RHODE ISLAND RESOURCE RECOVERY CORPORATION
 CENTRAL LANDFILL
 JOHNSTON, RHODE ISLAND

WETLAND PERMIT MODIFICATION

RIDEM FRESH WATER WETLAND APPLICATION MODIFICATION RESTORED CONDITIONS GCC SITE

RIDEM FRESH WATER WETLAND APPLICATION REQUEST FOR PRELIMINARY DETERMINATION LANDFILL GAS TO ENERGY EXPANSION PROJECT

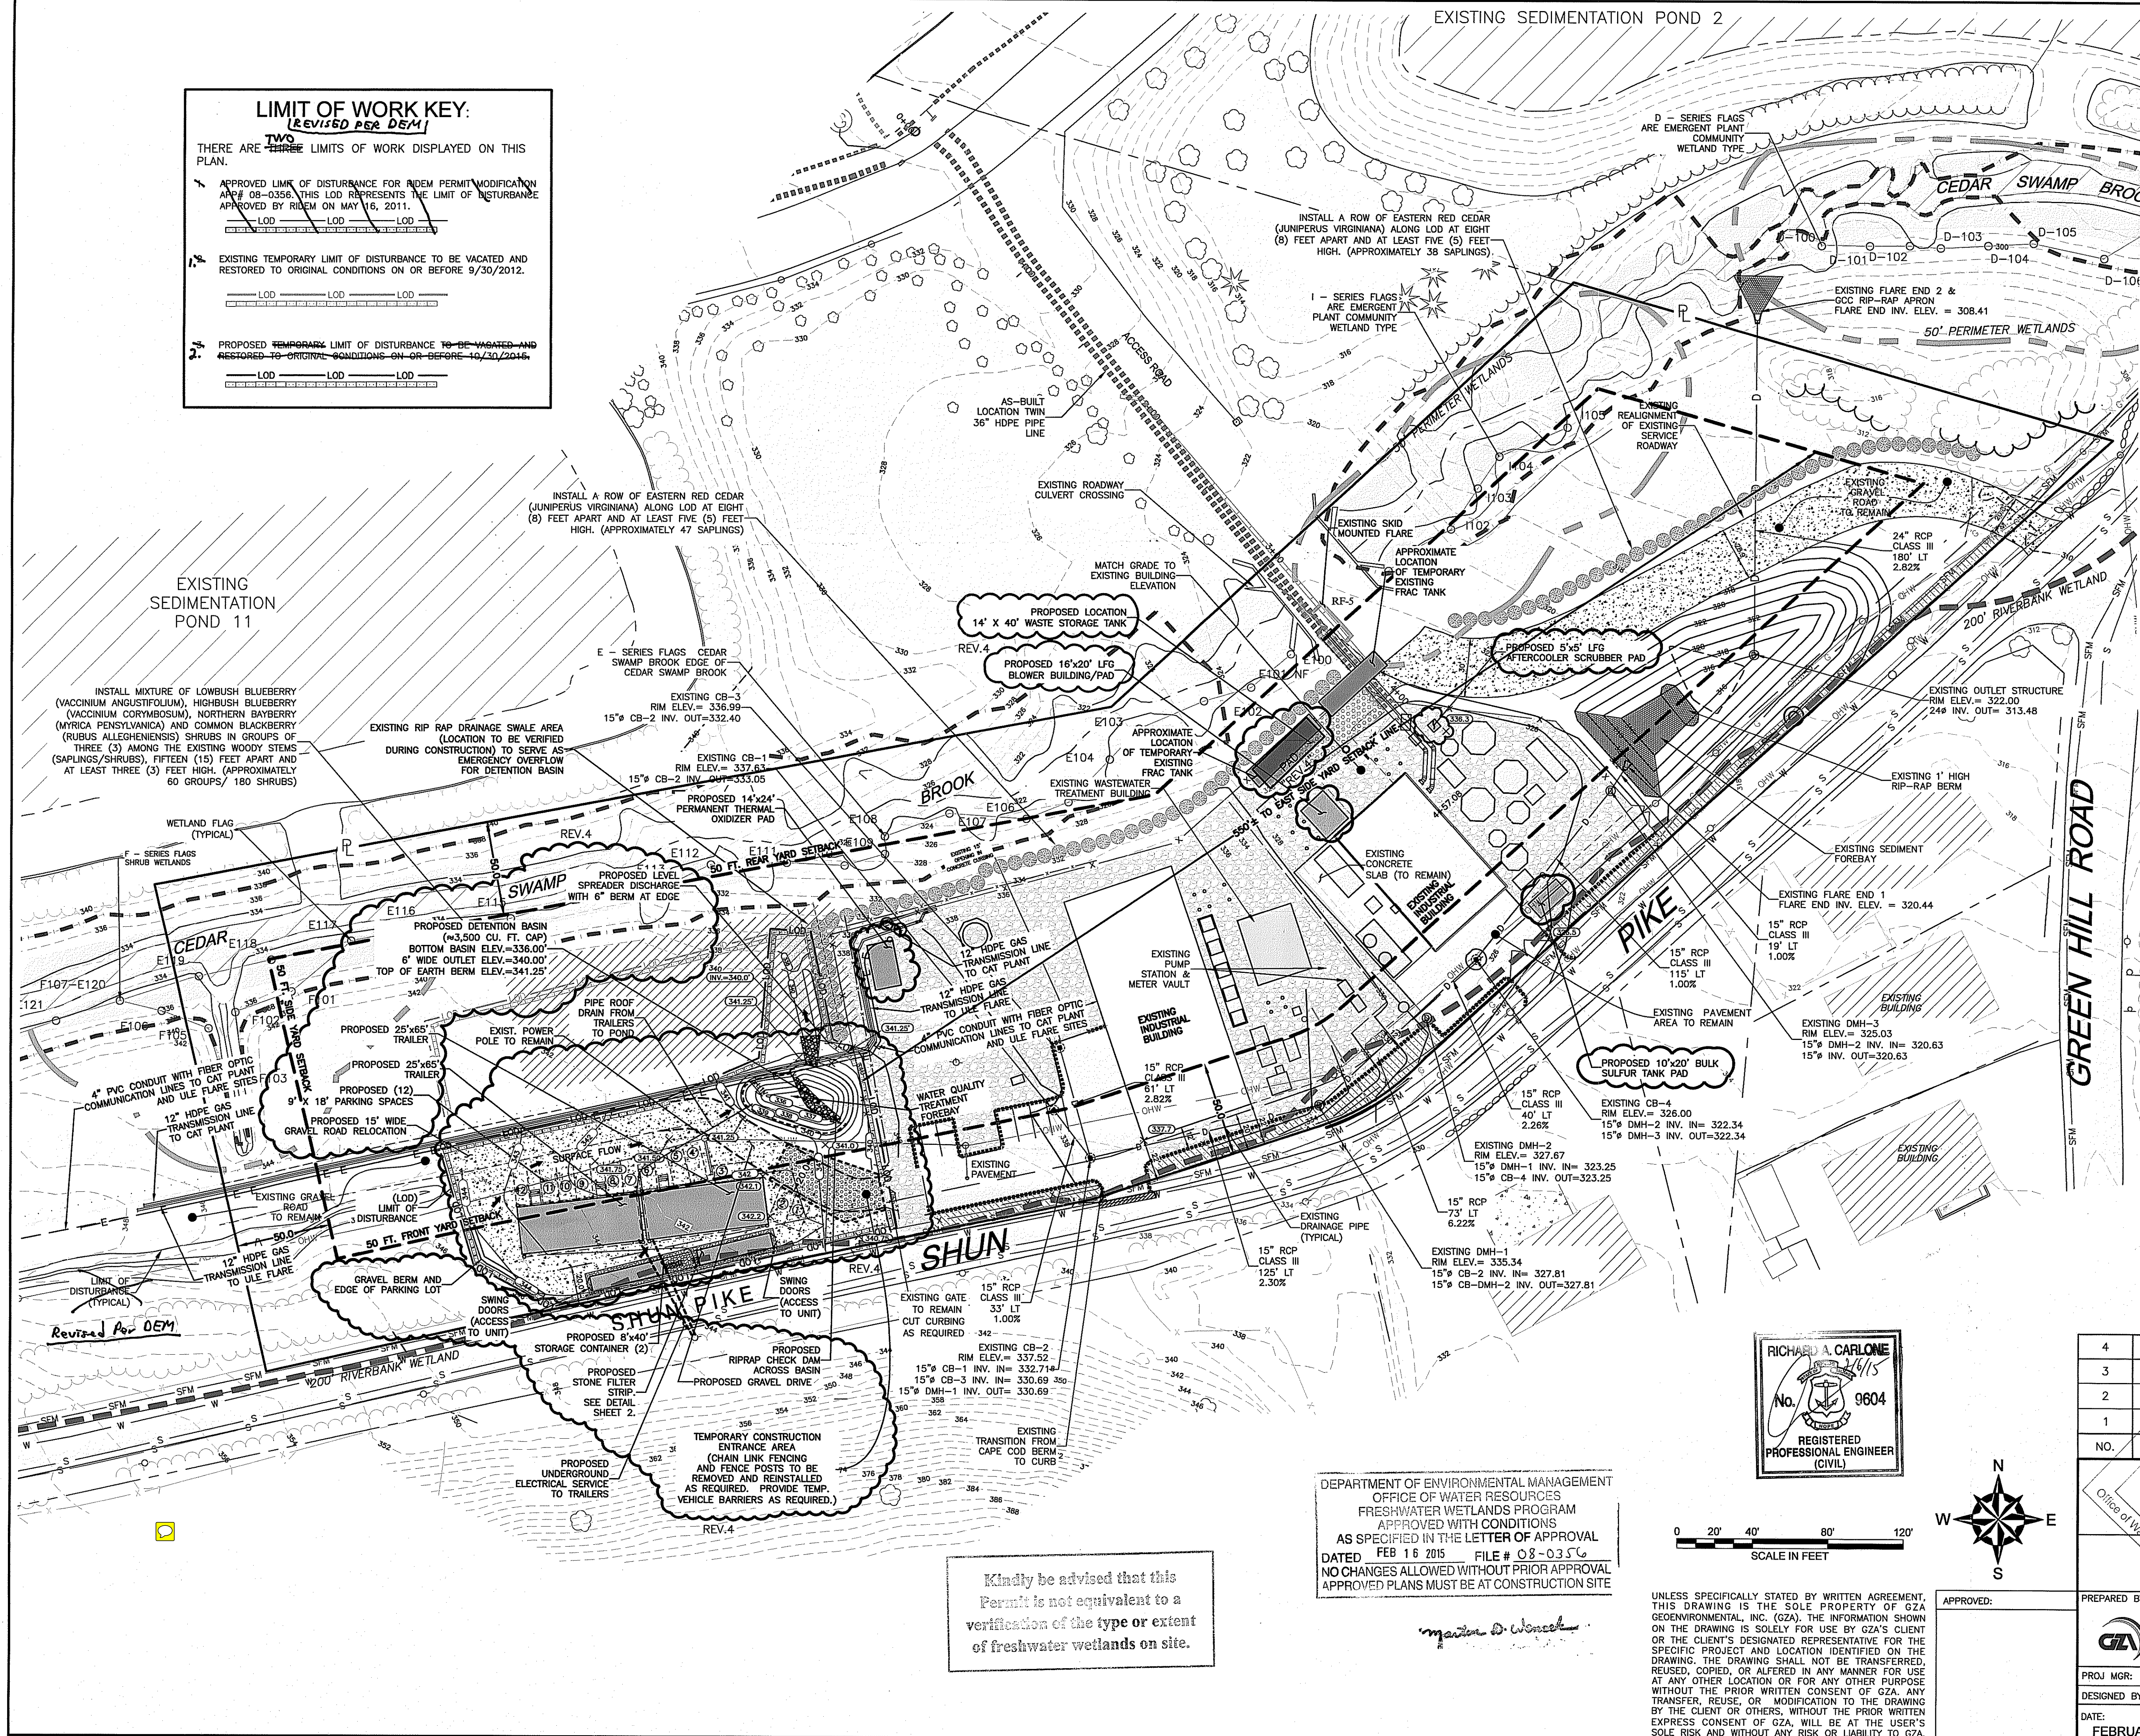
LIMIT OF WORK KEY:
 (REVISED PER DEM)

APPROVED LIMIT OF DISTURBANCE FOR RIDEM PERMIT MODIFICATION APP# 08-0356. THIS LOD REPRESENTS THE LIMIT OF DISTURBANCE APPROVED BY RIDEM ON MAY 16, 2011.

EXISTING TEMPORARY LIMIT OF DISTURBANCE TO BE VACATED AND RESTORED TO ORIGINAL CONDITIONS ON OR BEFORE 9/30/2012.

PROPOSED TEMPORARY LIMIT OF DISTURBANCE TO BE VACATED AND RESTORED TO ORIGINAL CONDITIONS ON OR BEFORE 10/30/2016.

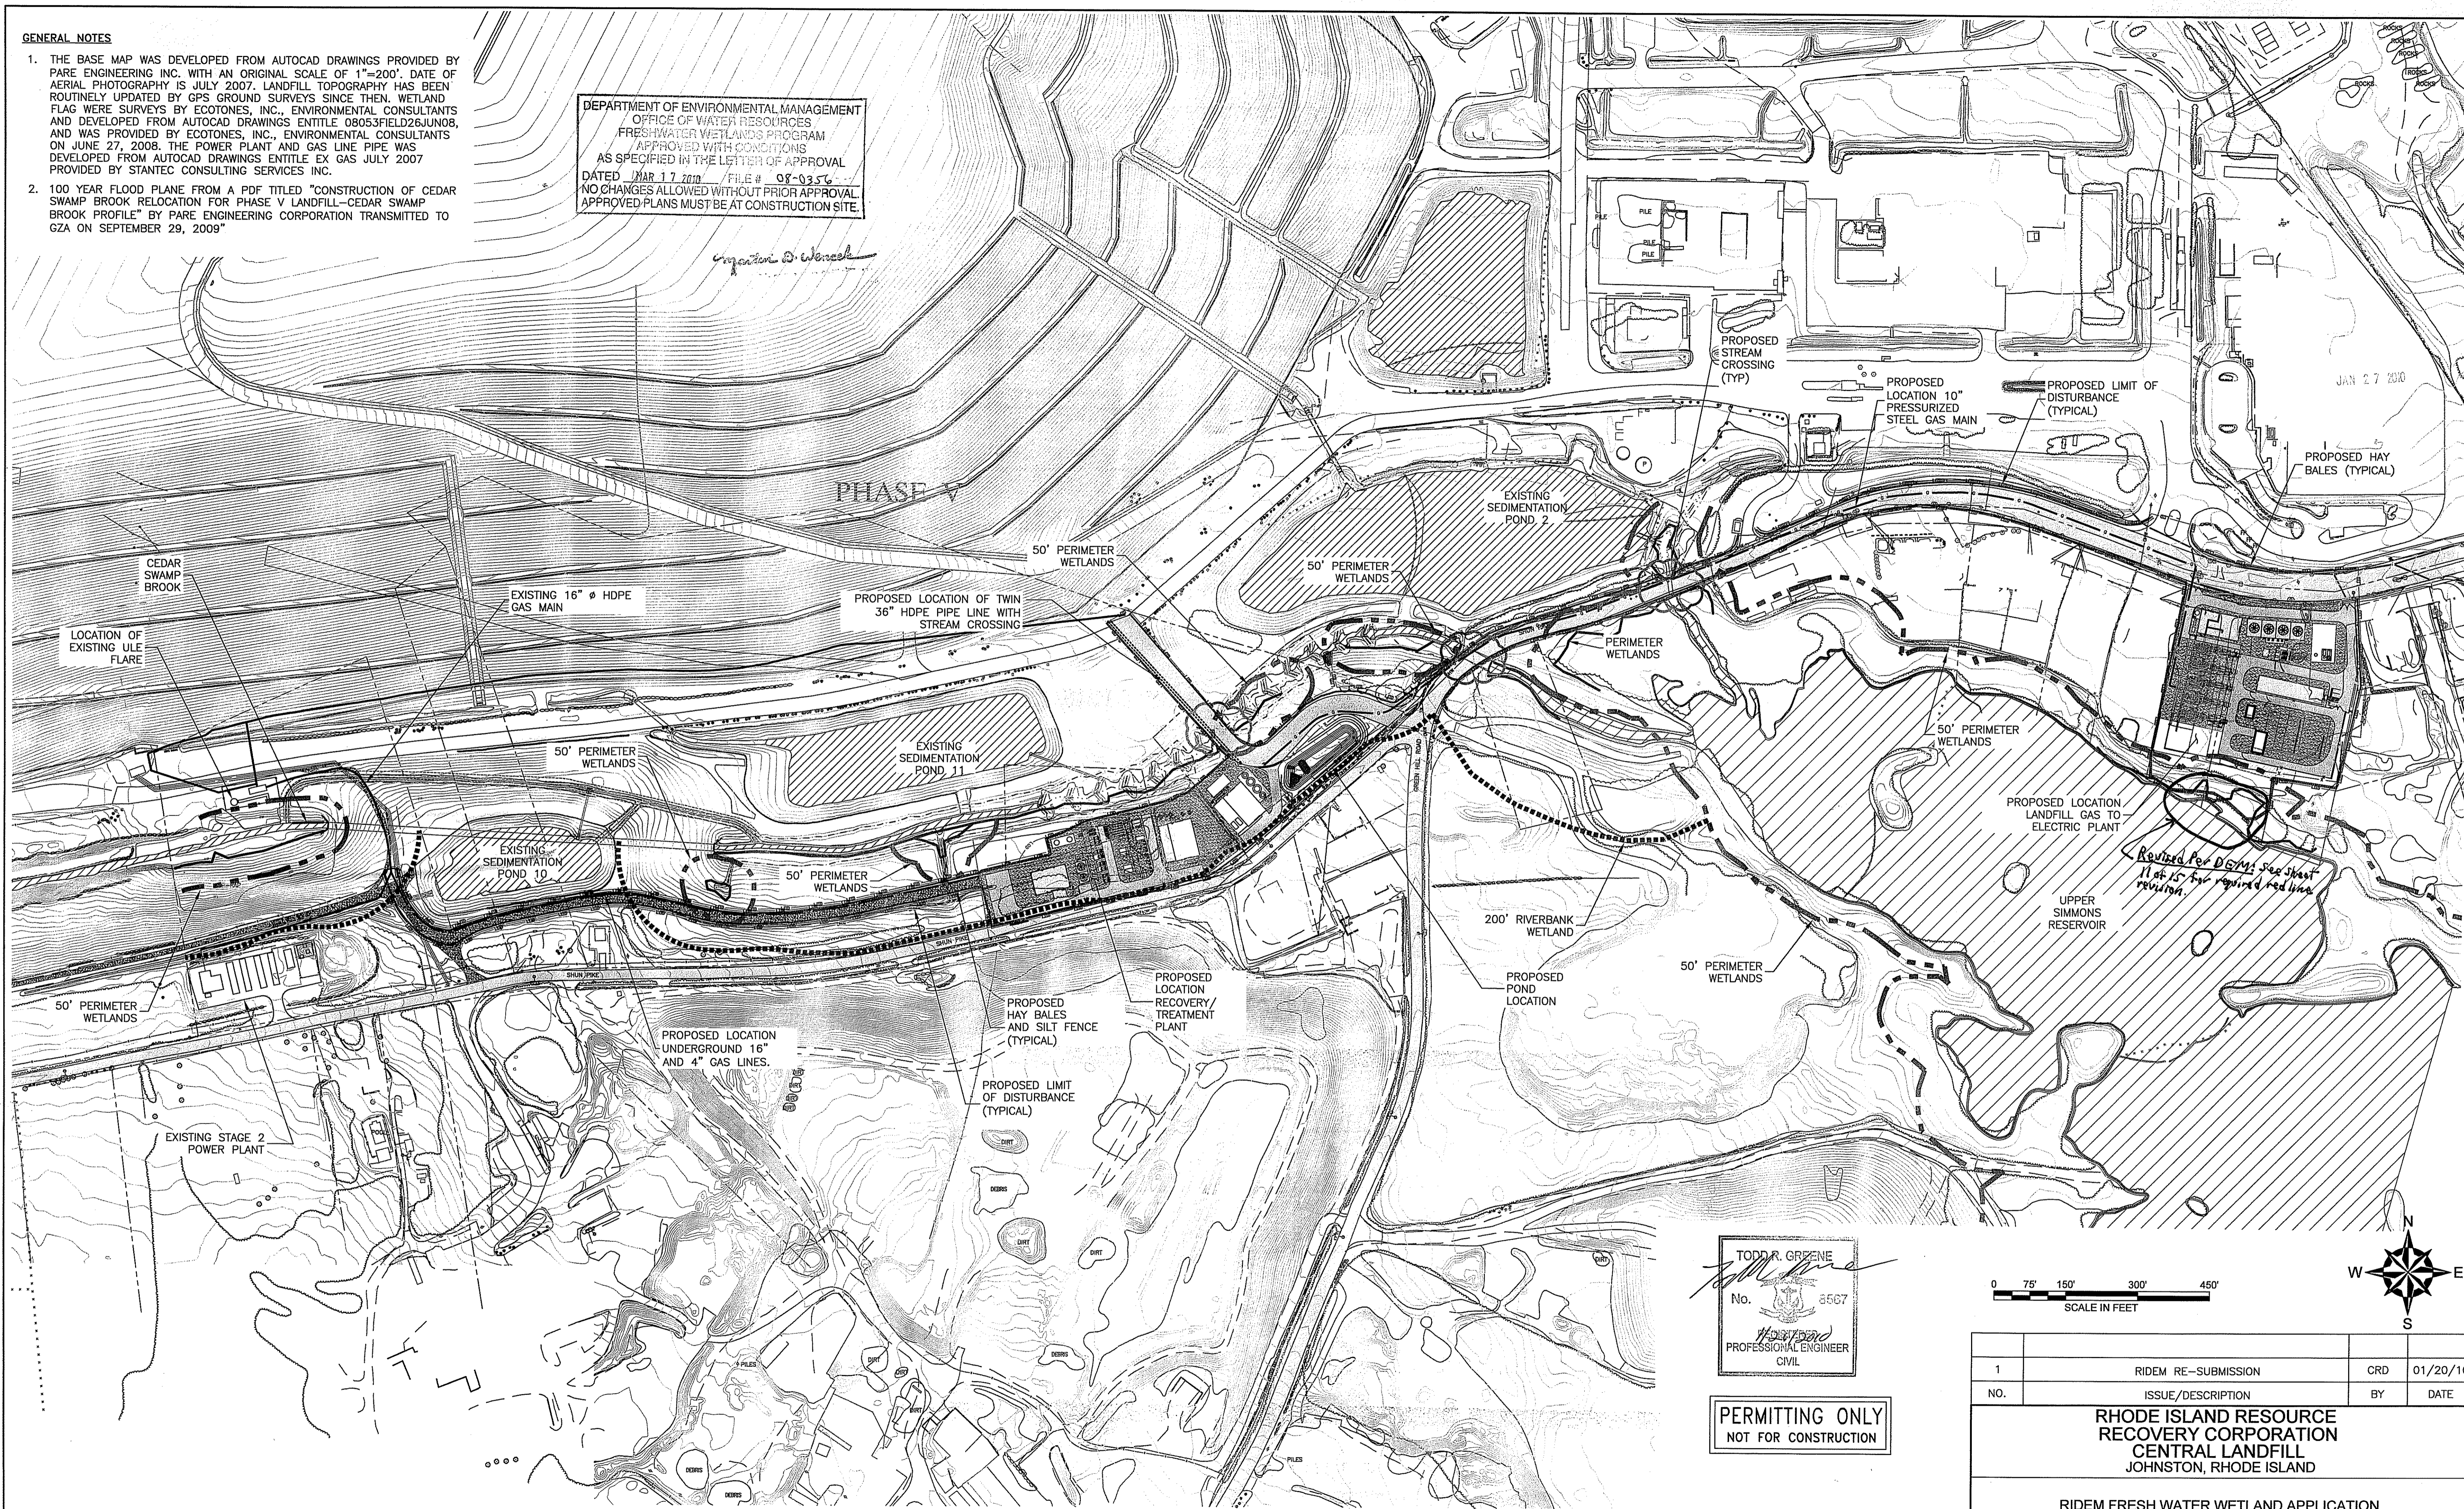
Revised per DGM. See sheet 11 of 15 for required red lines

**RIDEM FRESH WATER WETLAND APPLICATION
 PROPOSED CONDITIONS GAS LINE TO STAGE 2 POWER PLANT**

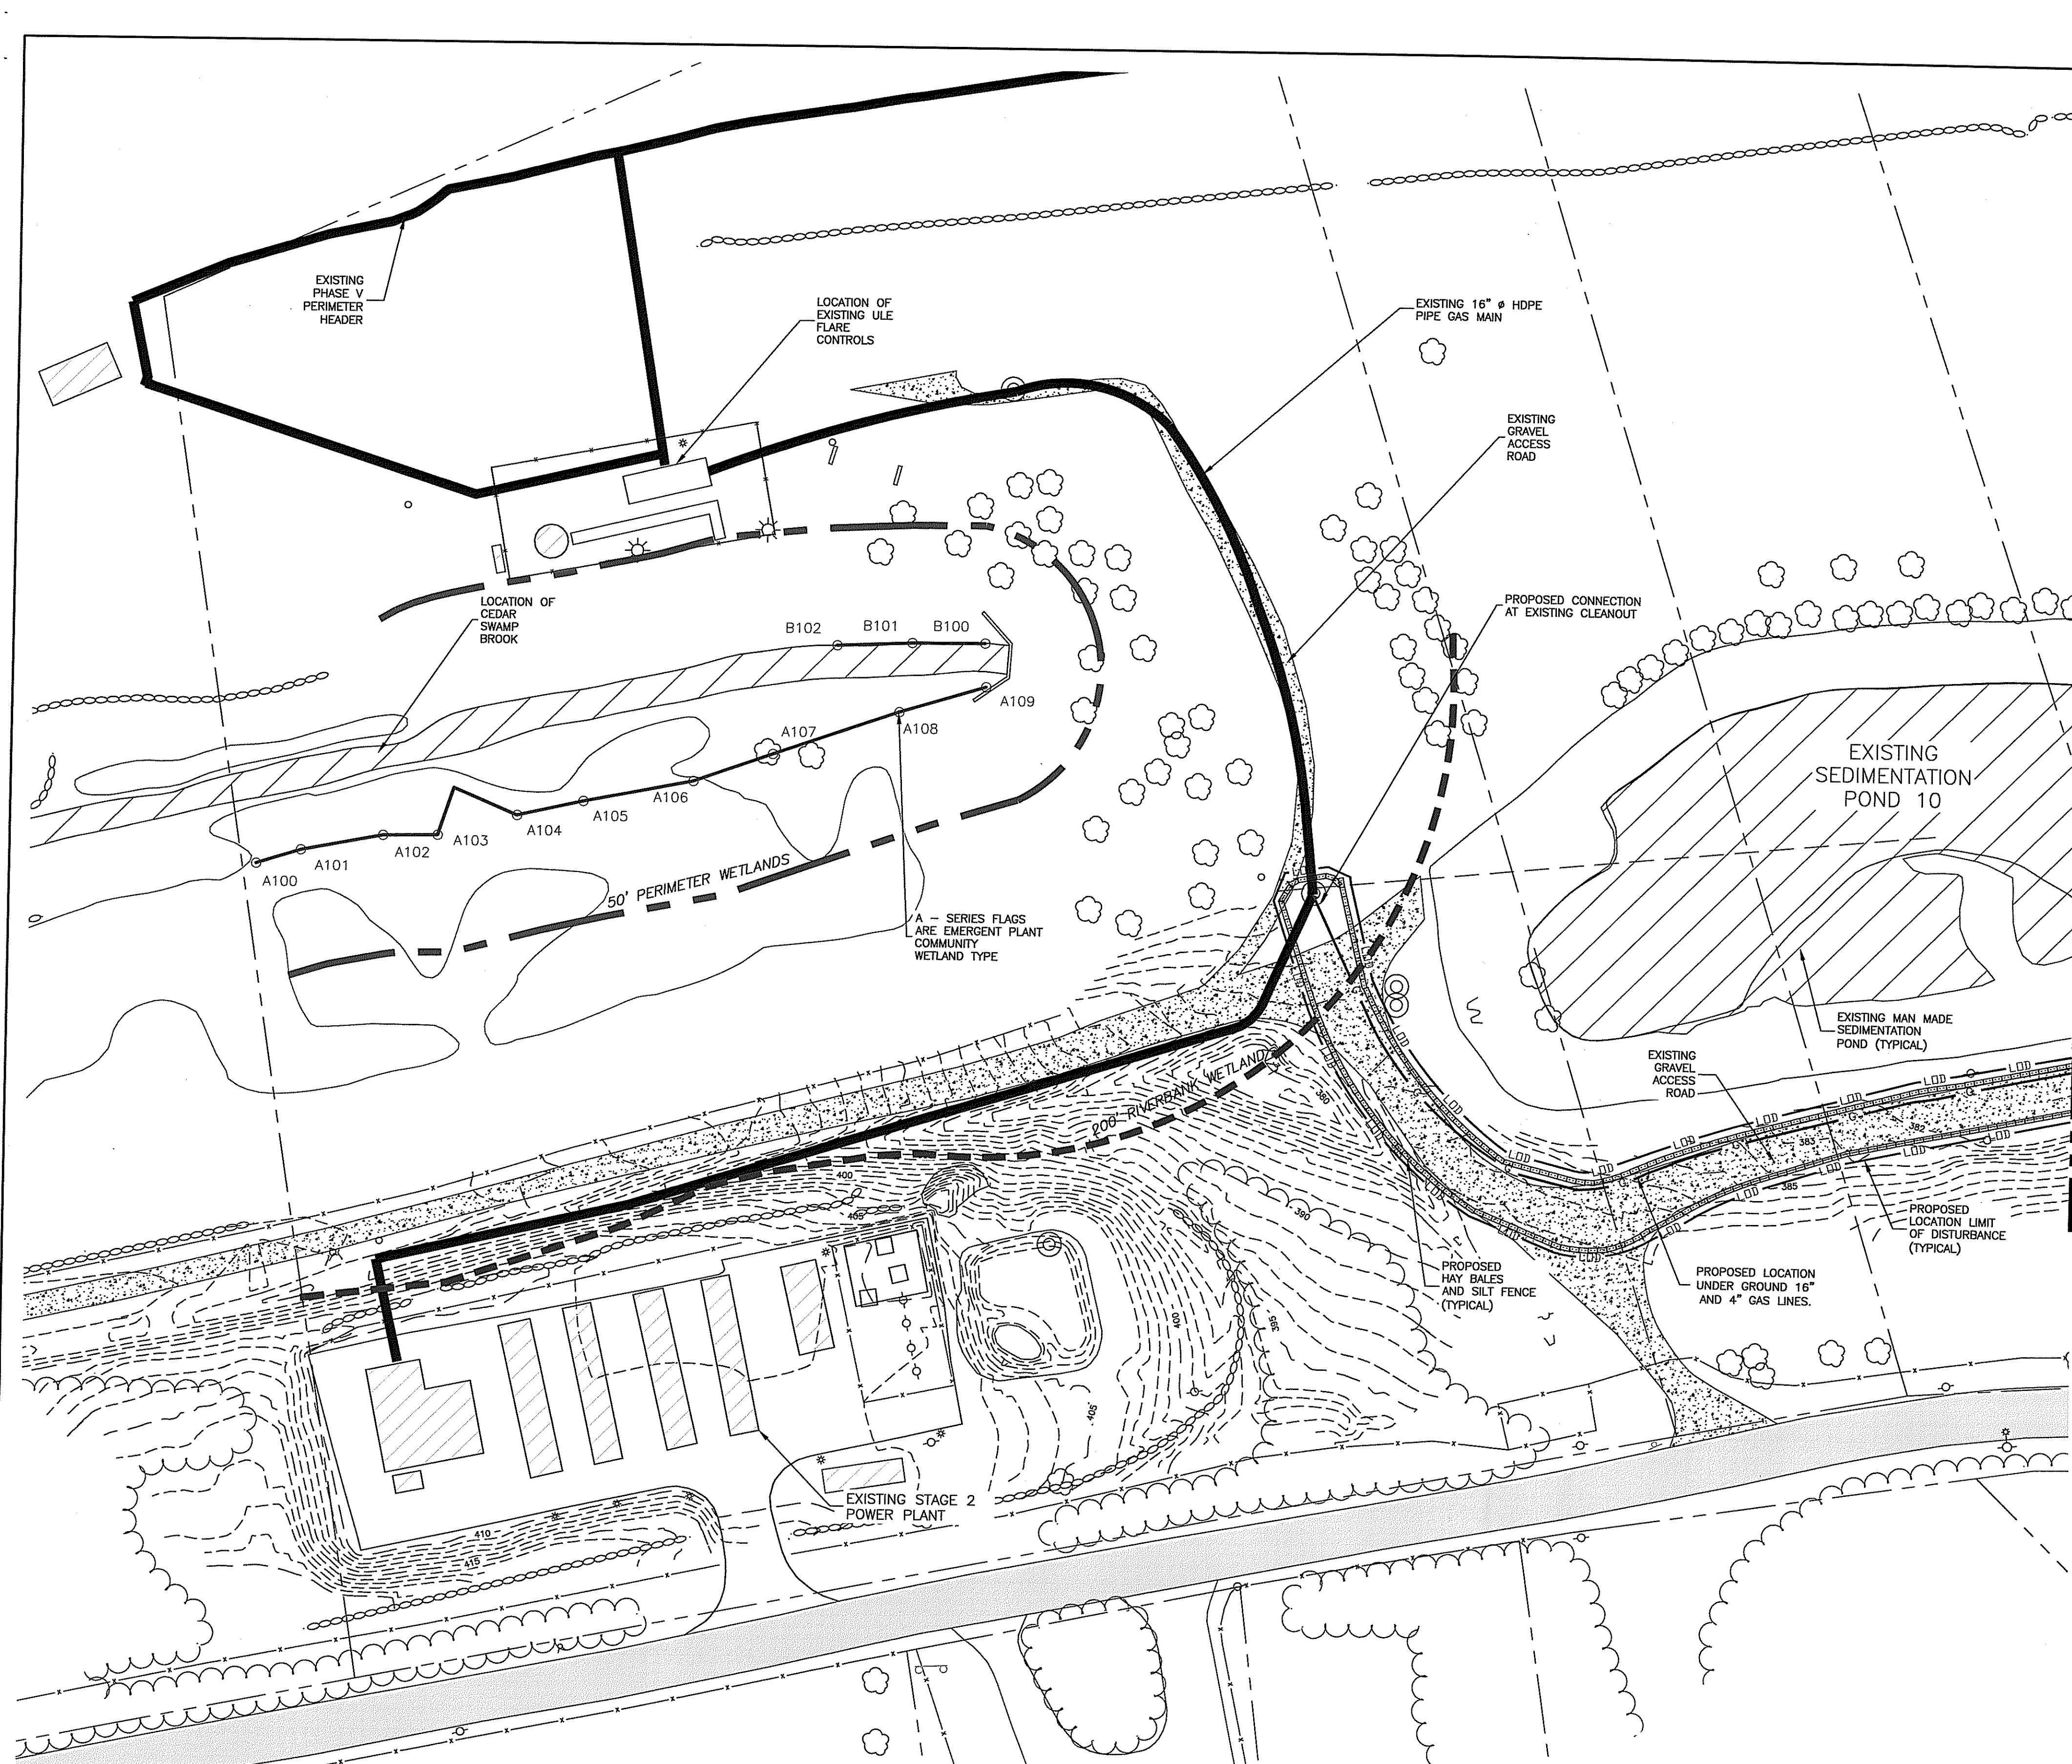
- PROPOSED SILT FENCE/HAYBALES ALONG LIMIT OF DISTURBANCE
- LOD LIMIT OF DISTURBANCE
- LOD TEMPORARY LIMIT OF DISTURBANCE
- PROPOSED GRADING
- PROPOSED CATCH BASIN
- PROPOSED DOUBLE CATCH BASIN
- PROPOSED DRAINAGE MANHOLE
- PROPOSED FLARE END
- PROPOSED GAS LINE UNDERGROUND WITHIN ROADWAY
- EXISTING TREE LINE
- PROPOSED TREE LINE
- EXISTING CONTOURS
- EXISTING STREAM
- FLAGGED WETLAND LINE
- EXISTING OVERHEAD WIRES
- PROPOSED RIP-RAP APRON
- 200' RIVERBANK WETLAND
- 50' PERIMETER WETLAND
- PROPOSED EVERGREEN TREES (Revised for DEM: install this at 11' offset)
- EXISTING GRAVEL AREA
- EXISTING ABUTTER LINE
- EXISTING FENCE
- PROPOSED FENCE
- EXISTING WALLS
- EXISTING PAVED AREA
- APPROXIMATE 100-YEAR FLOOD PLANE
- WETLAND AREA TO BE ENHANCED (Revised for DEM: install this at 11' offset)
